777

Service Bulletin

Number: 777-53A0075
Original Issue: January 14, 2015
Revision 1: December 14, 2015
ATA System: 5380

SUBJECT: FUSELAGE - Section 48 - Station 2370 Pivot Bulkhead Forward Outer Chord -
Inspection and Repair

FIGURE 15: LEFT SIDE - STA 2370 PIVOT BULKHEAD FORWARD CHORD - REPAIR
(SHEET 1 OF 22)

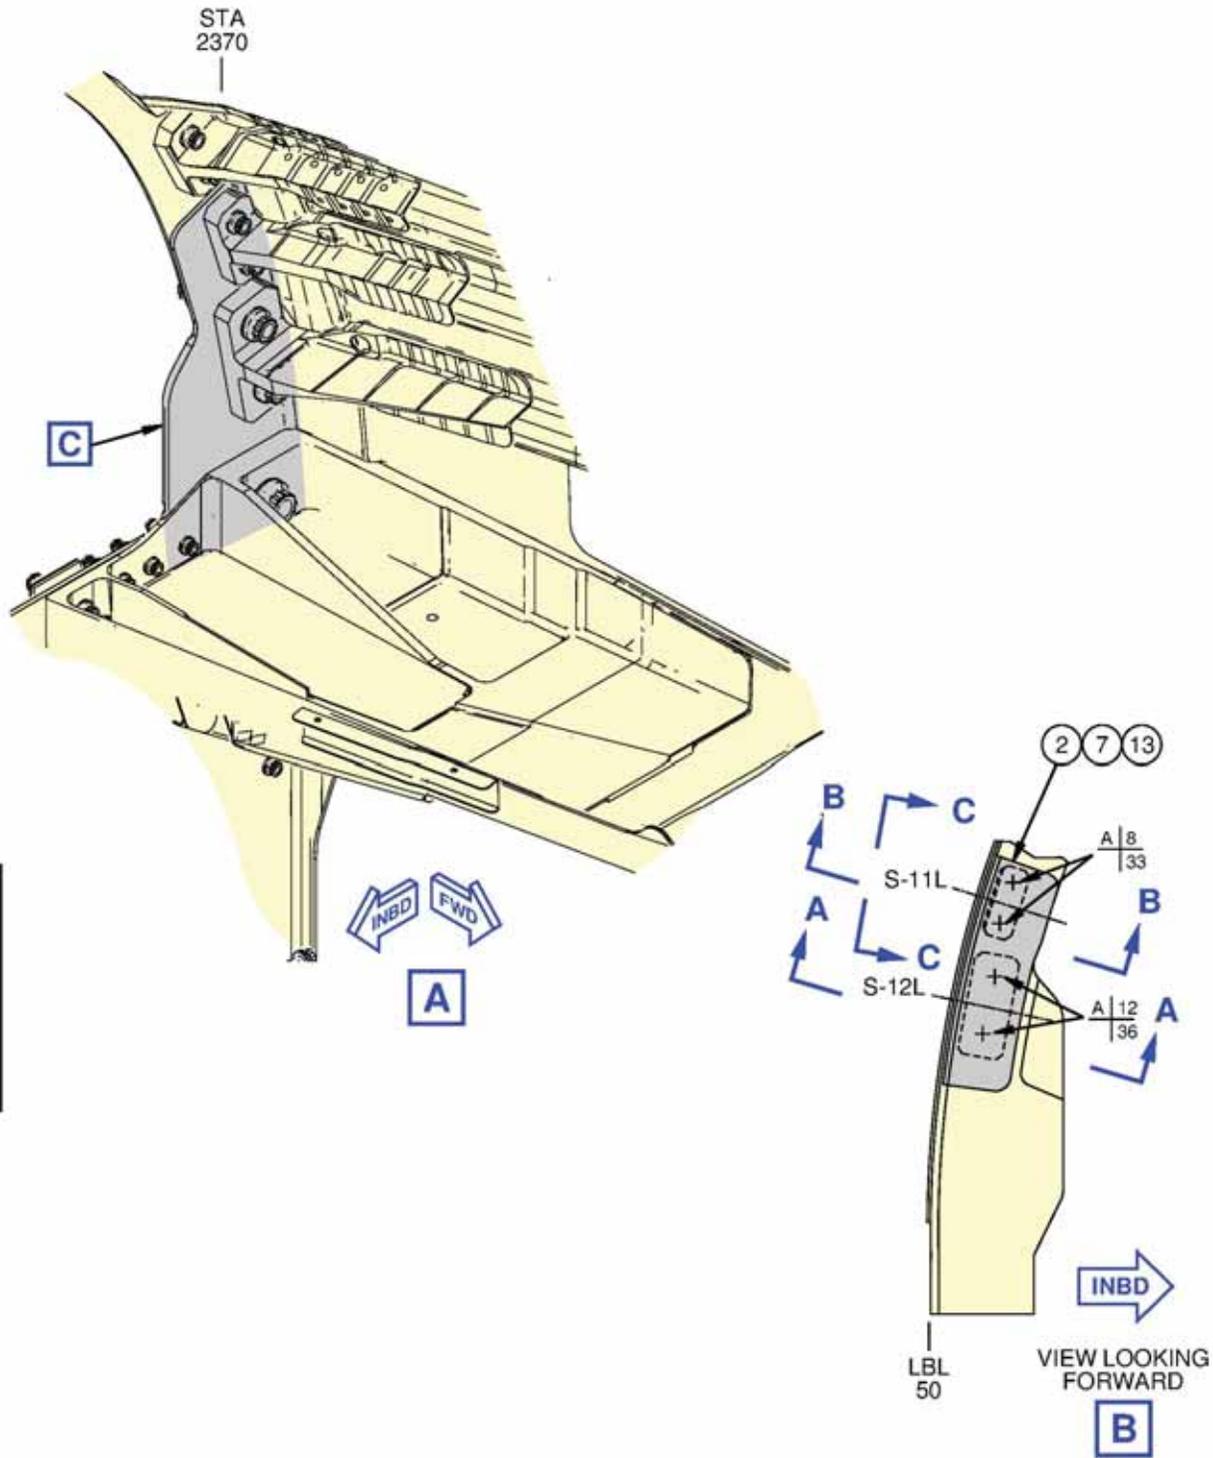
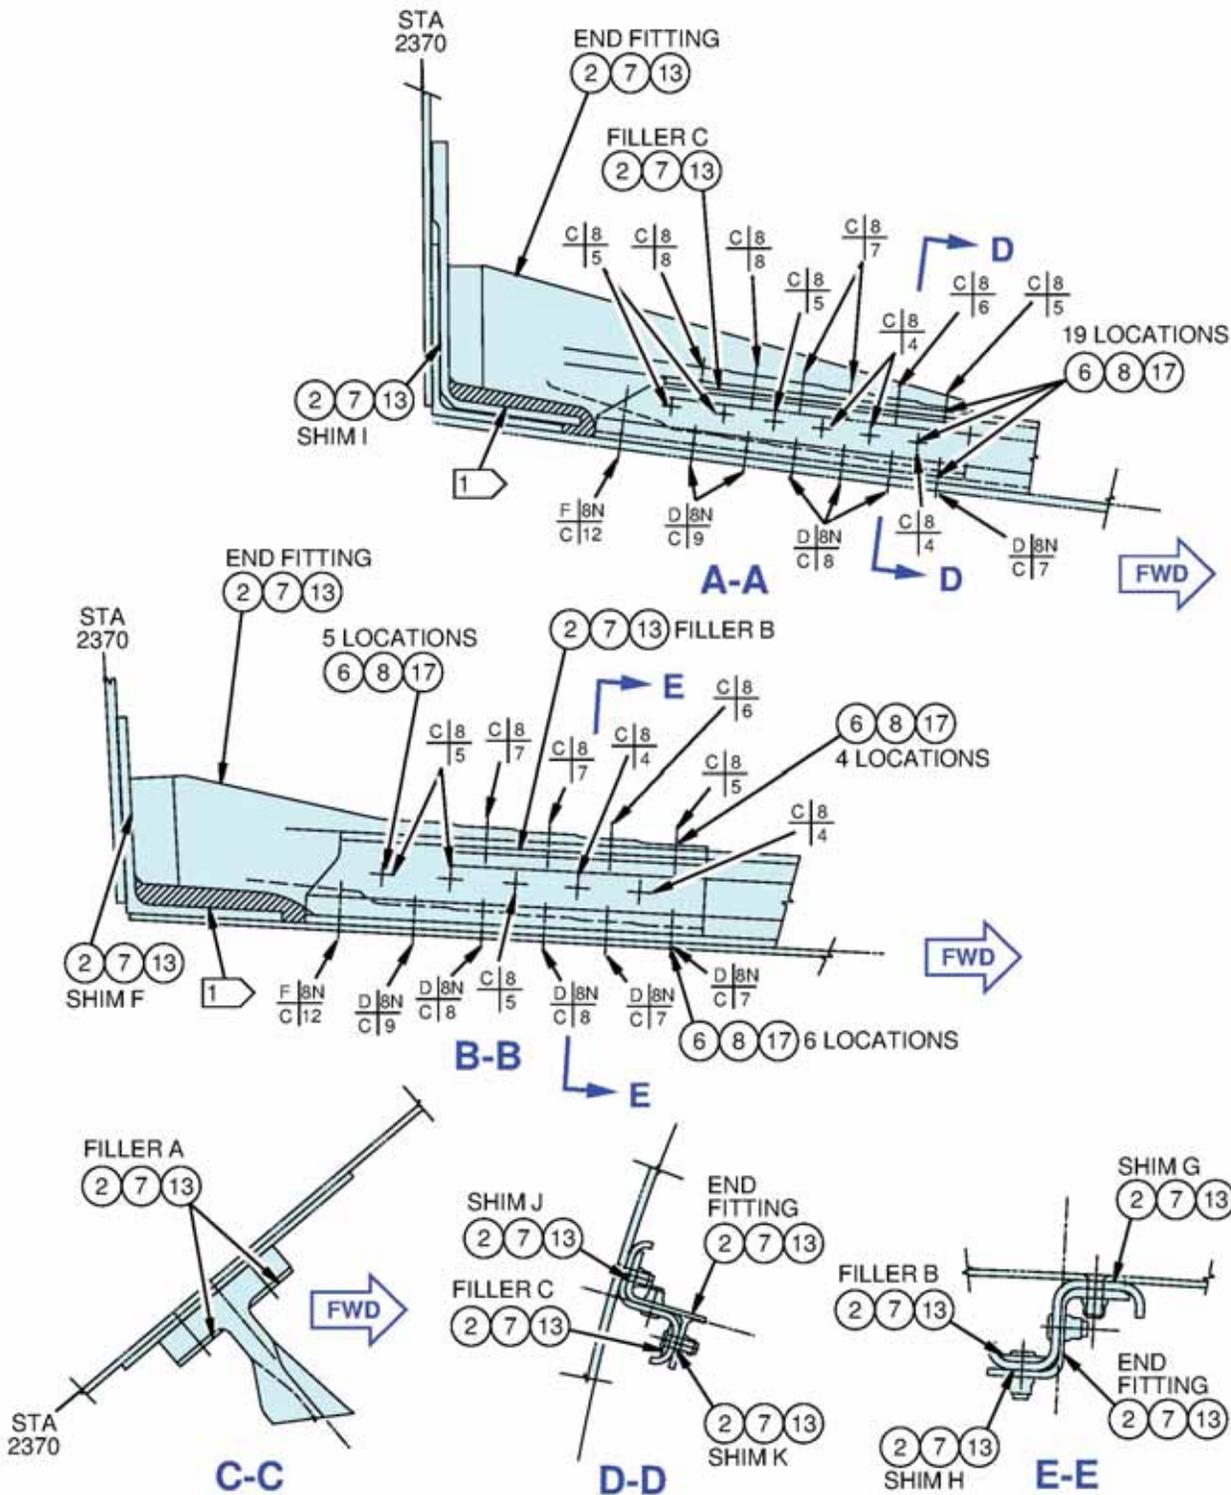
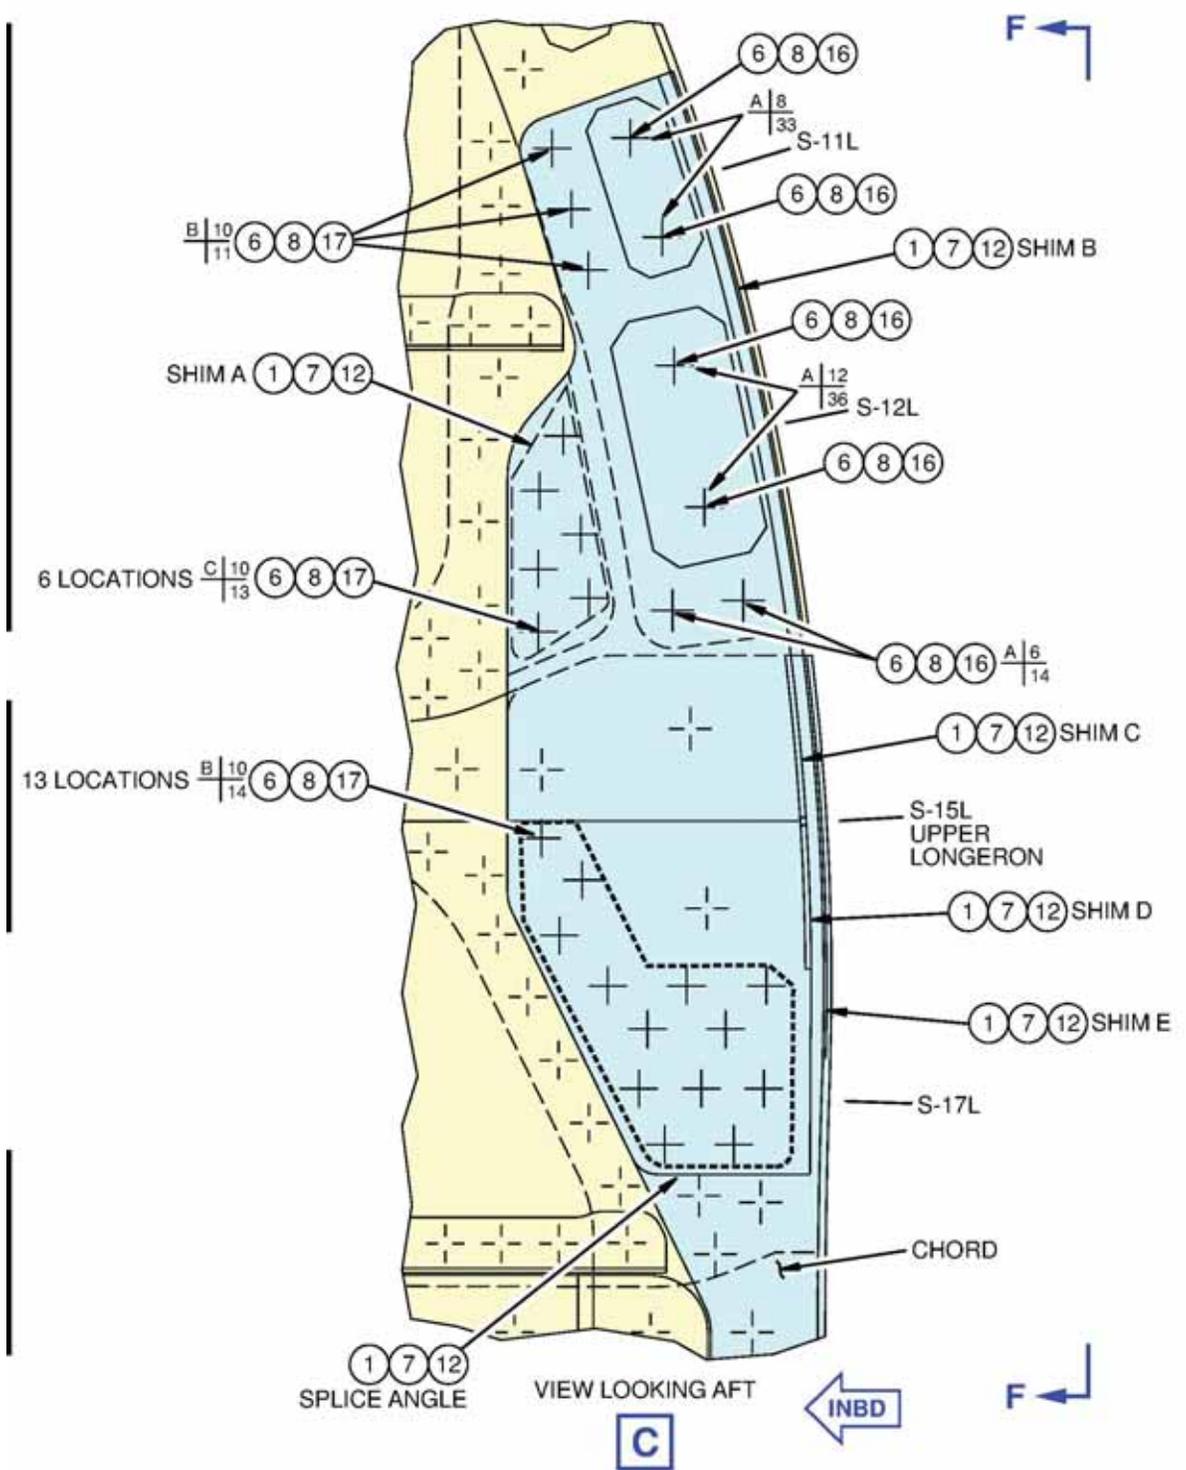
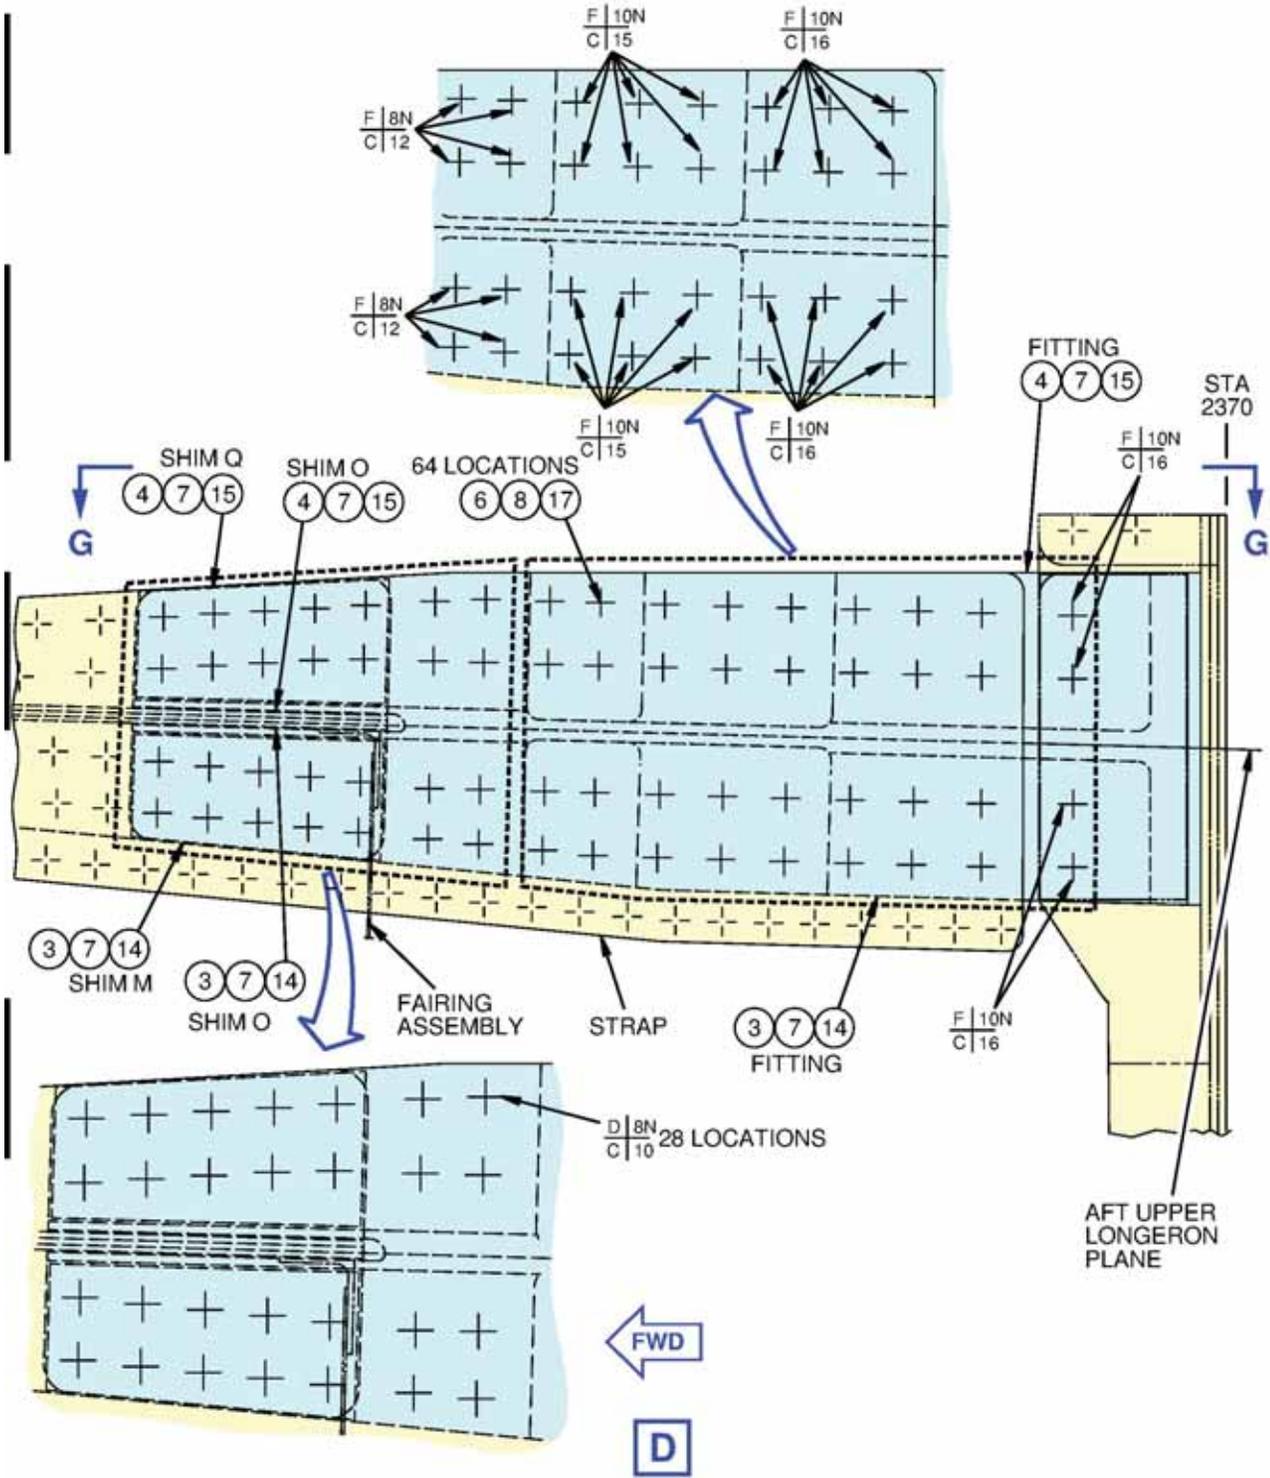
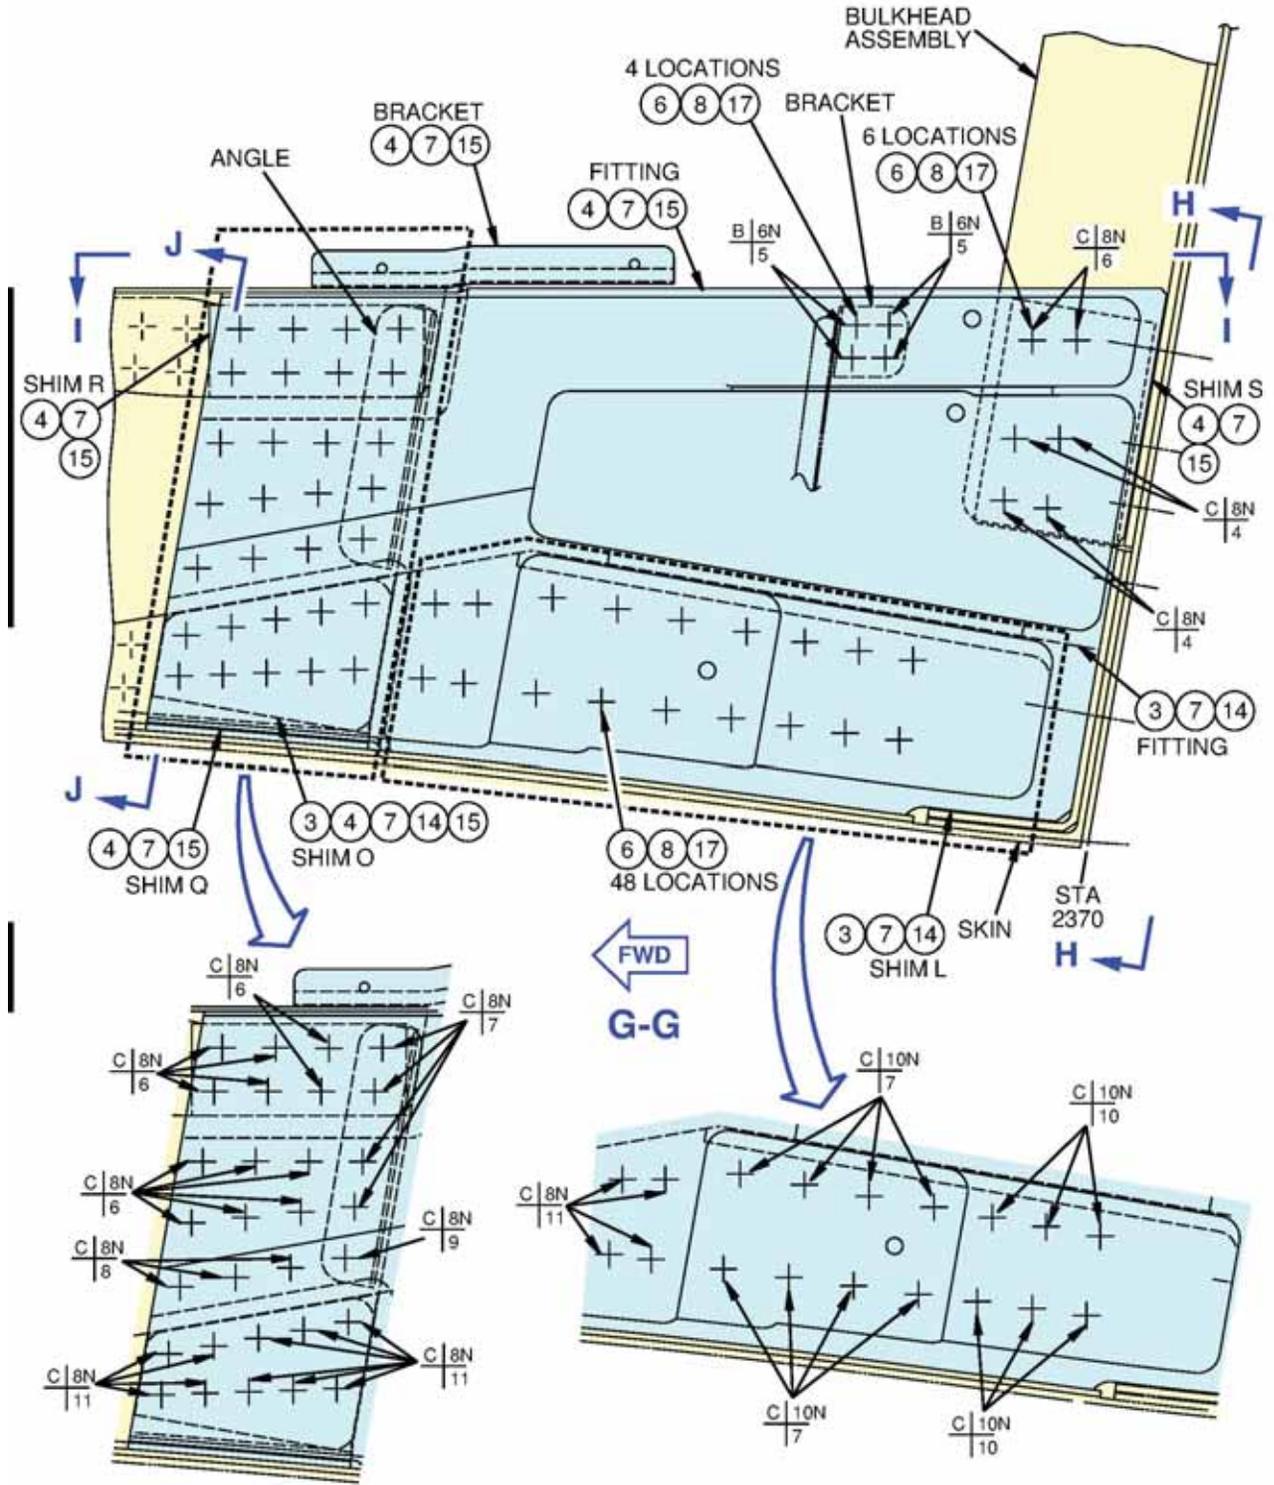
22. In Figure 15, Figure 16, Figure 17, Figure 18, Figure 21, Figure 22, Figure 23 and Figure 24, revised the illustrations, the step table and the fastener code table.
